RESPONSE TO SUBMISSIONS

16-24 Lord Street & 21-27
Roseville Avenue, Roseville

SSD-78996460

Prepared for
HYECORP PROPERTY GROUP
10 December 2025

Figure 4 Revised lower ground floor plan

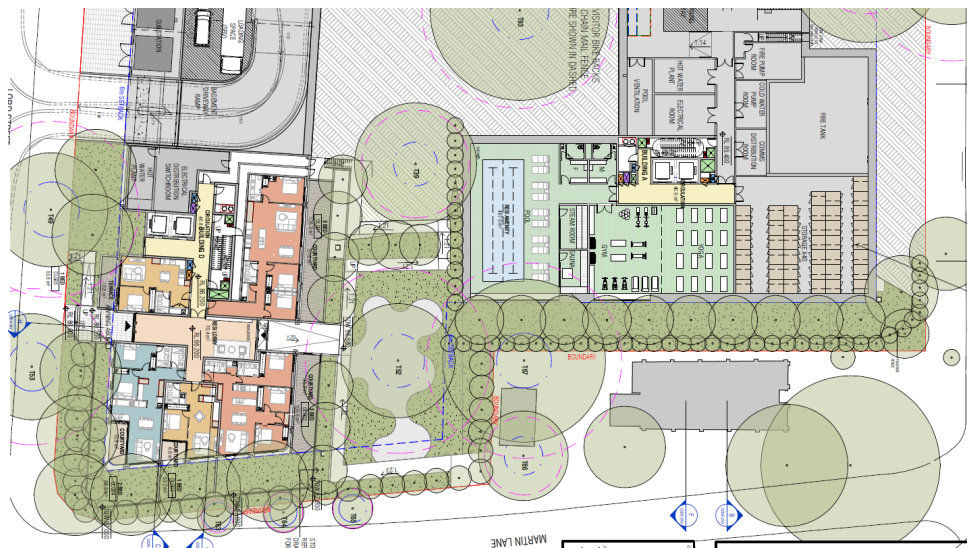
- The previously proposed flood wall to the eastern site boundary has been removed and all residential apartments have been raised to achieve the flood planning level plus freeboard. Lower ground floor town houses have been redesigned as single level apartments with the area below, situated below the FPL, being converted to non-habitable floorspace (refer **Figure 4** below).
- Expansion of residential gym and reconfiguration of amenities to replace the removed apartments.
- Delineation of bike storage areas to include a 30 space visitor storage cage, a 54 space resident bicycle store and 40 individual resident storage cages.
- Reconfiguration of service areas and car parking.

Figure 7 Conversion of Level 08 Private Open Space to Communal Open Space

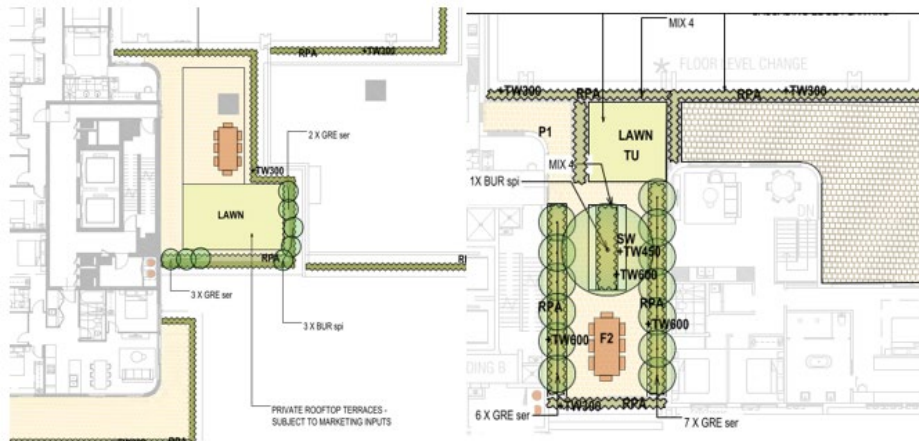
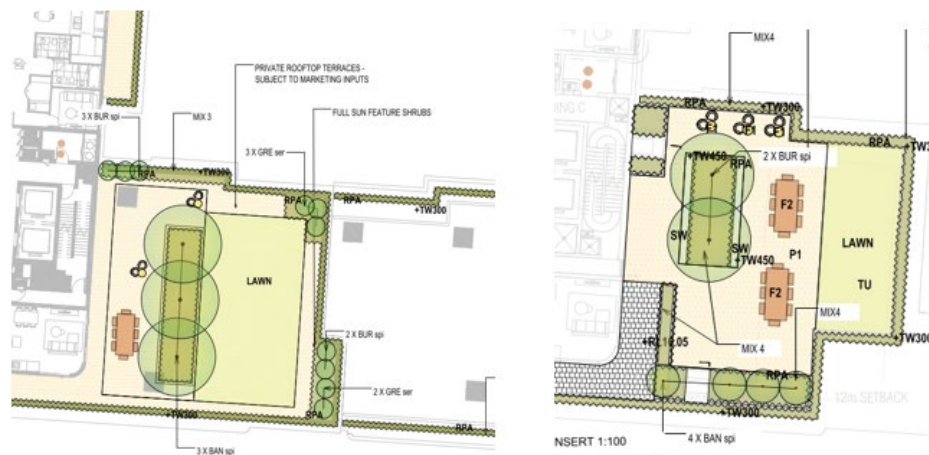
| Level 08 | <ul style="list-style-type: none"> Removal of the dogleg corridors in the North and South wings of Building B (response to DPHI key issue). |
| | <ul style="list-style-type: none"> Western balconies have been pulled back to comply with ADG setback requirements (response to DPHI key issue). Changes to numerous apartments to achieve greater amenity relating to daylight and natural ventilation (response to DPHI key issue). Updated apartment layouts to remove any dogleg corridors (response to DPHI key issue). Conversion of previous private open space to communal open space. See Figure 7 below. An additional three-bedroom apartment on the northern elevation. |

Figure 8 Level 8 balcony reduction

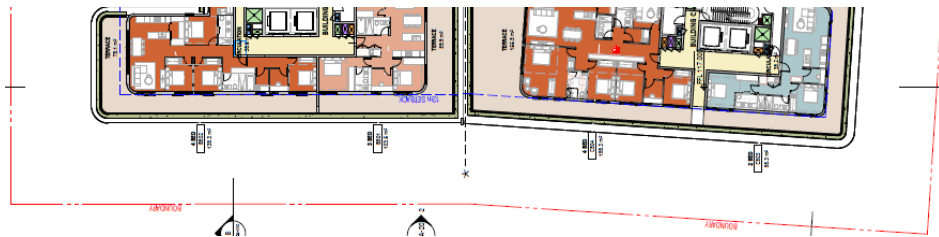
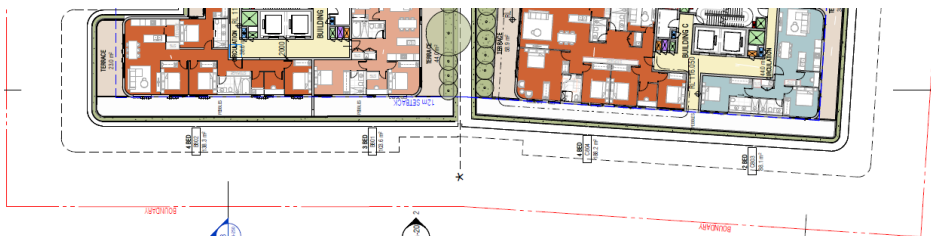
| East and West Elevations | <ul style="list-style-type: none"> West facing balconies on levels 4 and 8 have been amended so that they do not encroach into the ADG minimum setbacks to the western site boundary. Balconies previously extended over the roof slab below, this former balcony zone has been converted to non-trafficable roof area and will be treated with a pebble finish. See Figure 8 below (response to DPHI key issue). Façade material changes to include darker brick detailing and textured sandstone elements have been introduced to the penthouses |

<p>Figure 24 Landscape design – tree 93 (Flooded Gum)</p> 	
	<p>SSDA Lodgement Landscape Design</p>

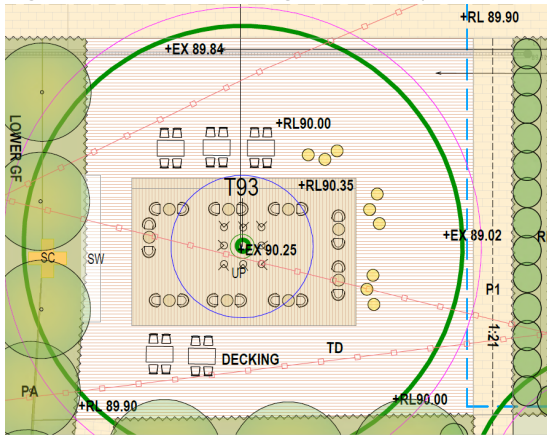
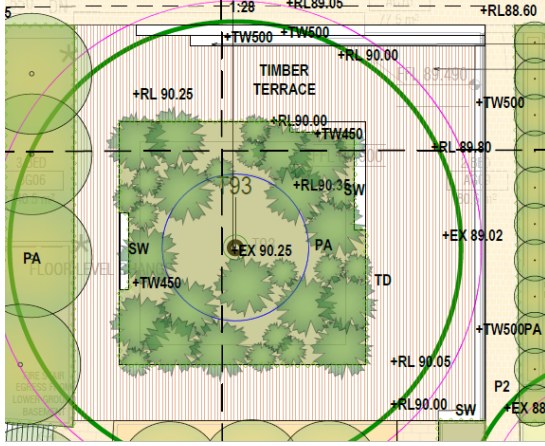
Summary of Issue Raised	Response	Refer to
<p>Provide a response to Council's concerns about the proposed works within the TPZ and SRZ of Tree 93, including updated landscaped plans as necessary to ensure the long-term retention value of this ecologically significant Sydney Blue Gum tree.</p>	<p>Trees recommended for removal due to unsustainable root loss (20 and 86) will be replaced with species in accordance with Council requirements.</p> <p>Council has been advised of the proposed removal of these street trees in conjunction with notification of the issue of the RtS to DPHI.</p> <p>As part of the updated Landscape Plans, the extent of decking surrounding tree 93 has been reduced. Please refer to the figure below which shows the increased soft landscape area now proposed surrounding tree 93.</p> <p>The updated AIA identifies that Tree 93 is recommended for retention and protection despite a 'major' (21% NRZ) encroachment from proposed seating walls, retaining walls, pathways and building/basement footprint. This level of encroachment, as well as the modification of surrounding site conditions may alter ground water movement and availability of nutrients and has the potential to result in a reduction to the assigned Useful Life Expectancy (ULE) rating and health/condition of this tree. The AIA proposes mitigation measures for root-sensitive design and construction of decking, pathways and seating walls, and project arborist supervision and tree protection measures throughout construction, to ensure the long-term retention of the tree.</p>	<p>Updated Landscape Plans</p> <p>Appendix D</p> <p>Updated Arboricultural Impact Assessment</p> <p>Appendix P</p>

Summary of Issue Raised	Response	Refer to
	 <p data-bbox="857 702 1198 734">Revised RtS Landscape Design</p> <p data-bbox="857 742 1086 774">Source: Land + Form</p>	
<p data-bbox="197 790 846 973">Provide updated landscape plans which demonstrate how the proposed landscape strategy is compatible with the landscaped ‘garden’ character of Lindfield. In addition, the landscape plan must address the following:</p> <ul data-bbox="212 989 846 1324" style="list-style-type: none"> ▪ clarify the number of trees to be retained and removed within the site. The Arboricultural Assessment Report outlines that 26 trees are to be retained on the site, however the Department notes that the majority of these trees are located outside of the site boundary. ▪ incorporate additional tree planting to demonstrate no net loss in trees on the site (excluding trees outside of the site boundary) 	<p data-bbox="857 790 1064 821">Garden Character</p> <p data-bbox="857 837 1848 981">The landscape design has been updated to align with Ku-ring-gai Council’s ‘garden’ character, defined by large private gardens, significant public green spaces, and a high tree canopy created by a mix of native and exotic species. The proposal reflects this character through:</p> <ul data-bbox="857 997 1848 1220" style="list-style-type: none"> ▪ Townhouse formats with direct street access, contributing to a landscaped streetscape. ▪ Formal garden spaces using recycled brick paving, native and exotic plantings, and high-canopy trees. ▪ A proposed tree canopy coverage of 39% of the site, exceeding the Government Architect’s <i>Greener Places Design Guide</i> benchmark of 25%. <p data-bbox="857 1236 1332 1268">Clarification of tree retention and removal</p> <ul data-bbox="857 1284 1848 1396" style="list-style-type: none"> ▪ Existing trees on site: 96. ▪ Trees to be retained: 6 (located within the site boundary). ▪ Trees to be removed: 90. 	<p data-bbox="1859 790 2042 949">Updated Landscape Plans</p> <p data-bbox="1859 917 2042 949">Appendix D</p>

Figure 25 Extent of first reserve

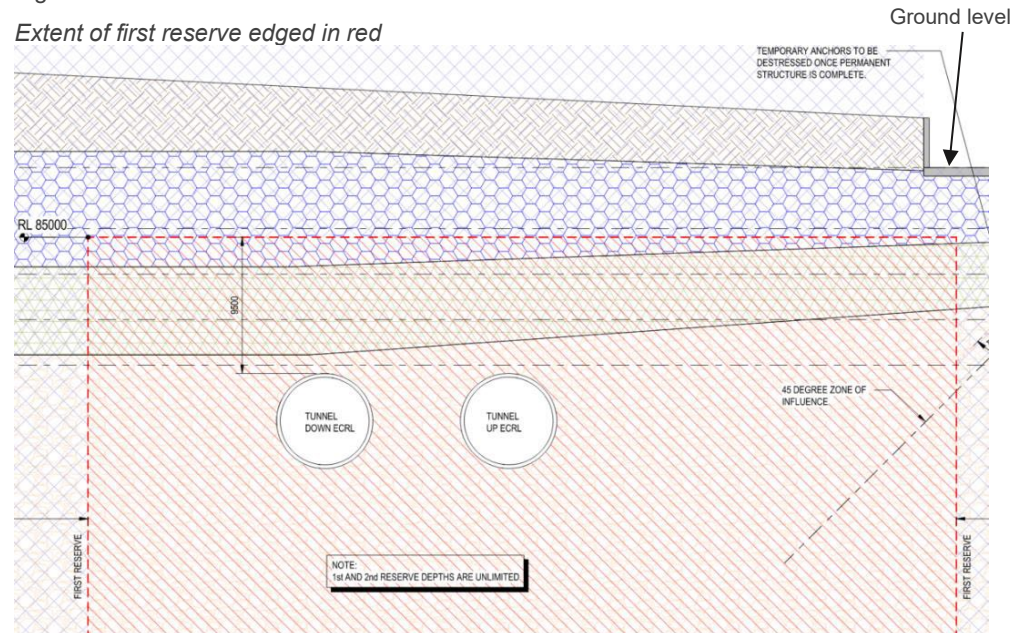
<p>Provide information on how tree removal and stormwater pits installation within the first reserve will be managed in line with the Sydney Metro Underground Corridor Protection Technical Guidelines.</p>	<p>Additional information has been obtained from Sydney Metro confirming the stratum location of the tunnel protection reserves. The first reserve is located below ground and is limited in height and depth. No works, including demolition, tree removal or stormwater pit installation, are proposed within the Sydney Metro First Reserve (refer to EIS Figure 36). Excavation work on land positioned directly above the first reserve is shallow in depth and does not protrude into the first reserve zone, as demonstrated in the documentation provided in Appendix N. The Sydney Metro Underground Corridor Protection Technical Guidelines specify the documents required to accompany a DA. All required documentation has been provided at Appendix N for referral to Sydney Metro.</p>	<p>Metro Impact Assessment Appendix N</p>

Figure 26 Deep soil area

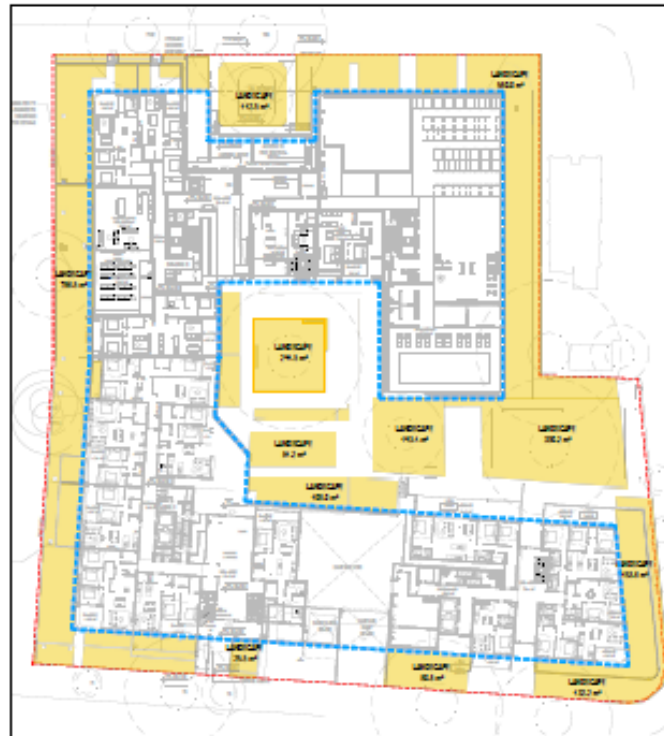
A revised deep soil plan is provided within the Landscape Report at **Appendix D**, ensuring hardstand areas are removed. The proposed deep soil zones exceed the ADG guidelines (being 15% of the site is pervious, and a minimum dimension of 6m). As shown in **Figure 26**, the proposal achieves 30% deep soil area on the ground floor and co-locates deep soil with COS in accordance with the ADG guidelines.

Figure 28 Rationalisation of Internal Corridors

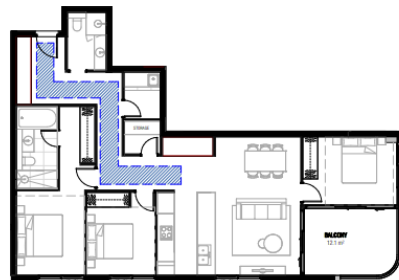
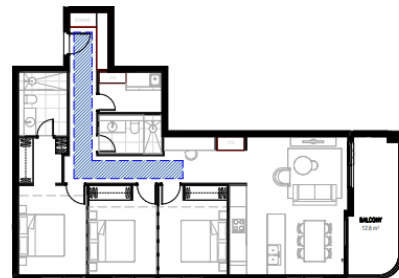
Summary of Issue Raised	Response	Refer to
<ul style="list-style-type: none"> - Refine apartments located at the internal corners of the proposal to mitigate visual and acoustic privacy impacts. 	<p>and massing makes a demonstrable improvement to the solar access to the existing neighbouring properties to the west.</p> <ul style="list-style-type: none"> ▪ Figure 2.19 of the Design Report Addendum provides an analysis of a typical proposed 3-bedroom townhouse against family-friendly design criteria. Key living spaces, such as kitchens and living rooms, are arranged to facilitate easy supervision of children, supporting a safe and connected family environment. Bedrooms and study areas are designed with flexibility to allow them to adapt to the evolving lifestyles and changing needs of growing children. ▪ As detailed in section 2.21 of the Design Report Addendum, apartment layouts have been refined to position bathroom entries away from main living areas and kitchens to enhance privacy and improve spatial comfort for residents. The revised design enhances privacy, establishes a clearer functional separation between living and utility spaces, and positions bathrooms more conveniently near the bedrooms. Consequently, bathrooms are no longer visible from the kitchen or living areas, resulting in improved spatial planning and a more comfortable living environment. ▪ As detailed at section 2.22 of the Design Report Addendum, apartment layouts have been revised to reduce the number of inboard kitchens and improve natural ventilation and daylight. Design Report Addendum Figure 2.22 details examples of improved kitchen layouts to a 2-bedroom apartment within Building D and a 3-bedroom apartment within Building A. ▪ The design of apartments located at internal corners of the development have been carefully refined to mitigate visual and acoustic privacy impacts. As detailed in Figure 2.23 of the Design Report Addendum, privacy screens and measures such as double-glazed windows are proposed to mitigate privacy impacts and enhance residential amenity.

Figure 32 Height limit exceedances

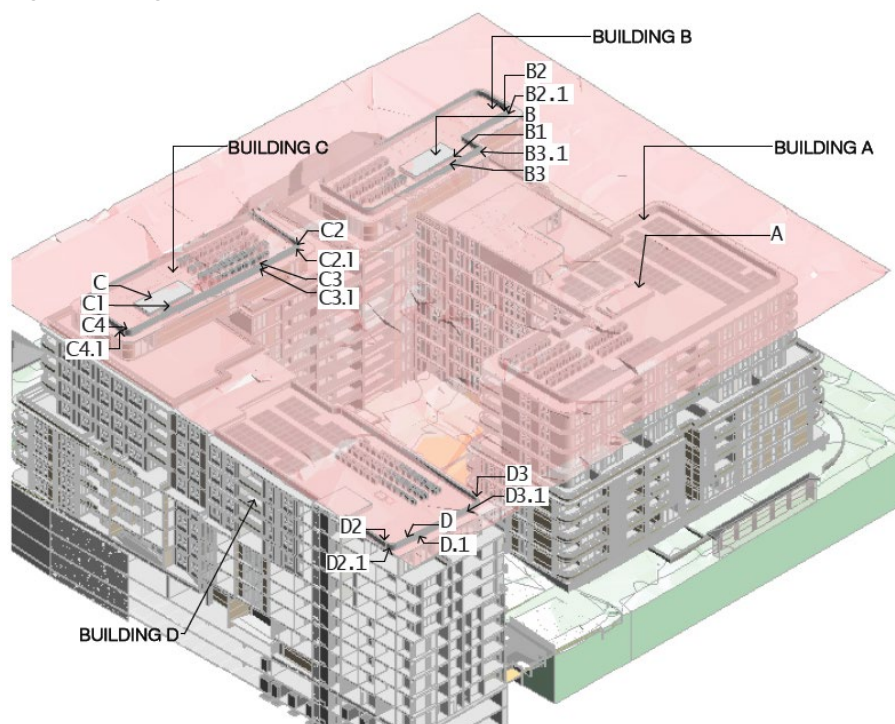
The architectural plans have been updated to include existing ground level RLs and building height RLs. The design has been revised as part of the Response to Submissions to generally comply with the maximum permissible building height.

As noted, there are minor exceedances proposed to the maximum permissible height, being three lift overruns and three portions of roof parapet. The maximum extent of this exceedance is 1.07m.

Figure 33 Proposed Basement 01 Plan

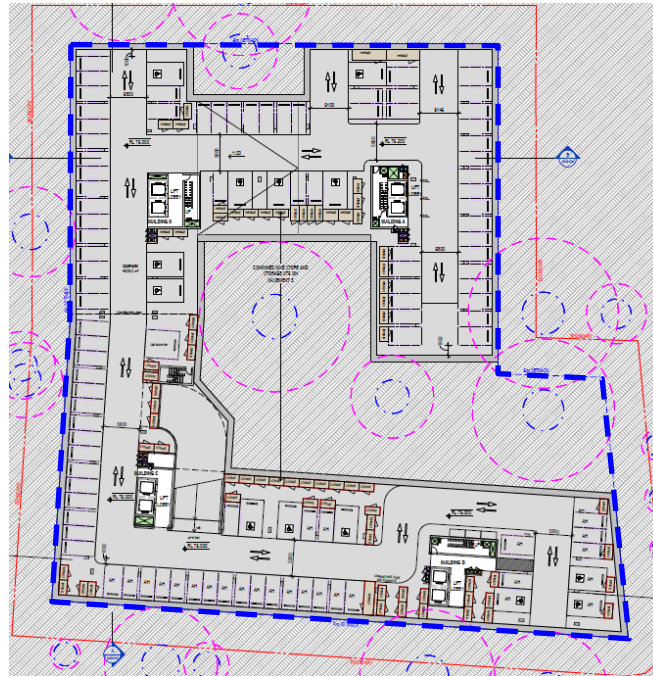
The setback encroachment compromises deep soil plantings and the growth of tall trees and is not acceptable (refer to Deep Soil Zones below).

Figure 36 Updated deep soil plan

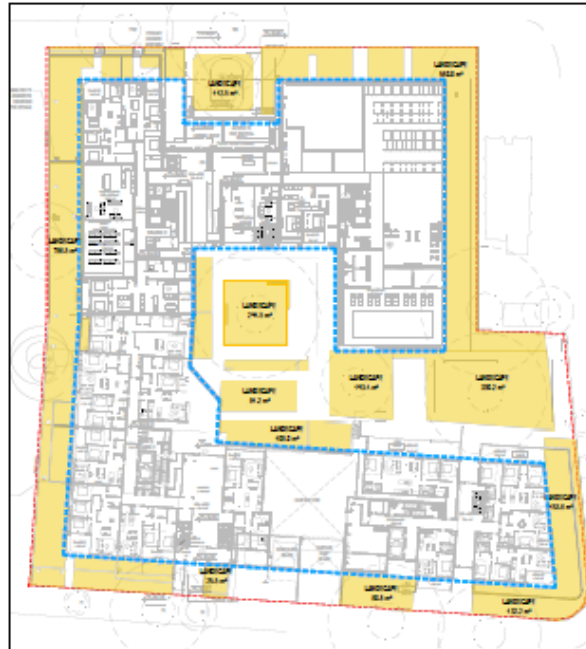
The sites' location within a heritage conservation area with a single residential context with large garden areas of deep soil, a minimum 15% / 1405.6sqm of the site area to be deep soil should apply.

Figure 37 Landscape design – tree 93

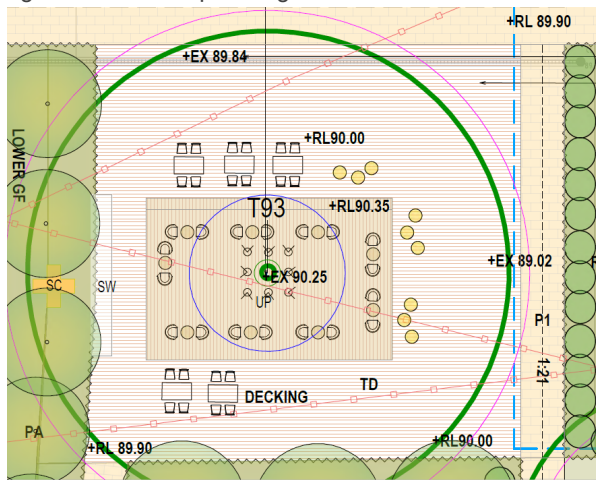
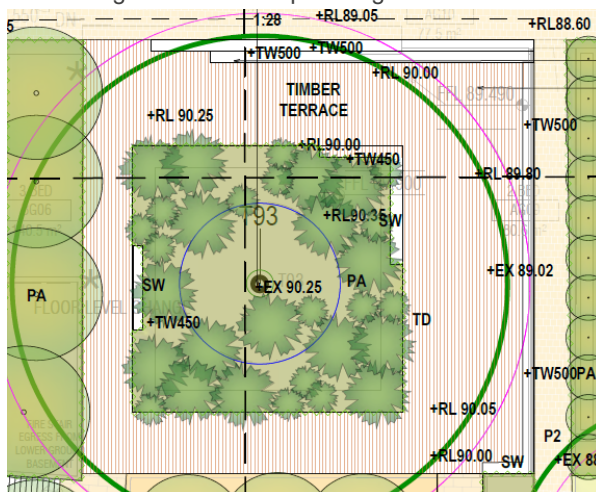
Design amendments are necessary to ensure the viable retention of these significant trees and to align with ADG and KDCP objectives.

Figure 43 Proposed shoring layout

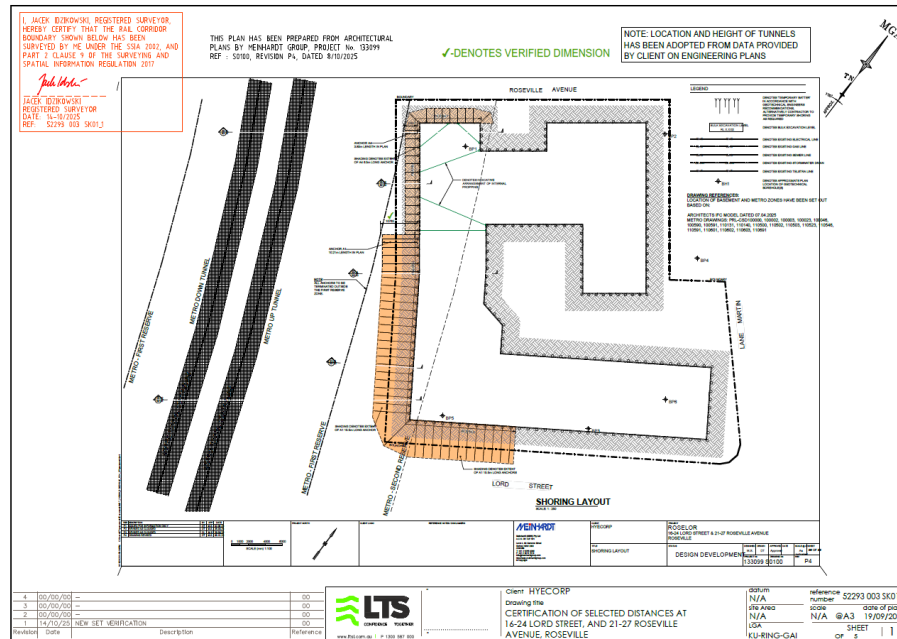
All structural and excavation methods have been designed to protect the integrity of the Metro corridor, with ongoing liaison between the project team and Sydney Metro to ensure compliance with technical requirements. A plan certified by LTS Surveyors mapping the reserve boundaries against the proposed shoring layout is provided at **Figure 43** below.

Note: The metro first reserve is limited in height and depth. No works are proposed within the first reserve
